Access Compliance Report

Public Rights-of-Way (Curb Ramps)

Intersection ID: 44232	Main Street: PAPER_BIRCH_DR	Cross Street: MAIDENHAIR_CT	Location: NW
ADA ID: CD83D4B6D5E8	Ramp Type: Perp	Initial Pass/Fail: Fail	Overall Compliance: No
Severity Score: 12.5			
Codes/Mitigation Info/Possible Solution		Field Measurements/Component Compliance

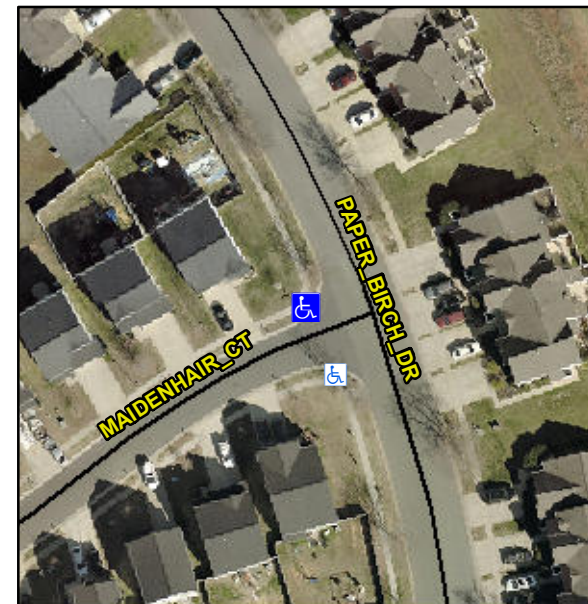
Not Found, R304.2.2

Compliance	Description	Data	Compliance	Description	Data
N/A	Ramp Length (in)	45.5	No	Ramp Slope (%)	9.2
Yes	Ramp Width (in)	48.0	Yes	Ramp XSlope (%)	1.7
N/A	Flare Type LT	N/A	N/A	Flare Type RT	N/A
N/A	Flare Slope LT (%)	N/A	N/A	Flare Slope RT (%)	N/A
N/A	Flare Traversable LT?	N/A	N/A	Flare Traversable RT?	N/A
N/A	Landing Length (in)	N/A	N/A	DWS Provided?	N/A
N/A	Landing Width (in)	N/A	N/A	DWS Contrast?	N/A
N/A	Landing Slope (%)	N/A	N/A	DWS Length (in)	N/A
N/A	Landing X Slope (%)	N/A	N/A	DWS Full Width?	N/A
N/A	Landing Curb? (Y/N)	N/A	N/A	DWS Offset (in)	N/A
N/A	Shared Landing?	N/A			
N/A	Gutter Ponding?	N/A	N/A	Gutter Slope (%)	N/A
N/A	Gutter Lip Ht (in)	N/A	N/A	Gutter X Slope (%)	N/A
N/A	Painted X Walk1?	No	N/A	Painted X Walk2?	N/A
	X Walk 1 Direction	To S		X Walk 2 Direction	N/A
N/A	X Walk 1 Width (in)	N/A	N/A	X Walk 2 Width (in)	N/A
	X Walk 1 Slope (%)	1.6		X Walk 2 Slope (%)	N/A
	X Walk 1 X Slope (%)	6.4		X Walk 2 X Slope (%)	N/A

Remove & Replace Entire Ramp.
